ADA Compliance Program

Clark County Facilities Transition Plan Mabry Corrections Facility

Date of Survey: October 31, 2006

Fig. 705.5
Truncated Dome Size and Spacing

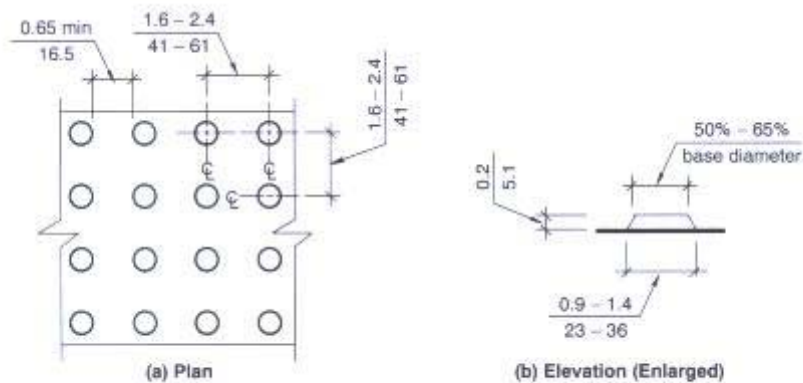
Location: Sidewalk crossing driveway entrance

Item: No detectable warnings on sidewalk crossing driveway.

Requirements: Detectable Warnings

IBC- Section 1102 Definitions – Detectable Warnings – A standardized surface feature built in or applied to walking surfaces or other elements to warn visually impaired persons of hazards on a circulation path.

ANSI Code: 705.2 Standardization – Detectable warning surfaces shall be standard within a building, facility, site or complex of buildings

ANSI 705.5 Truncated Domes – Detectable warning surfaces shall have truncated domes complying with Section 705.5
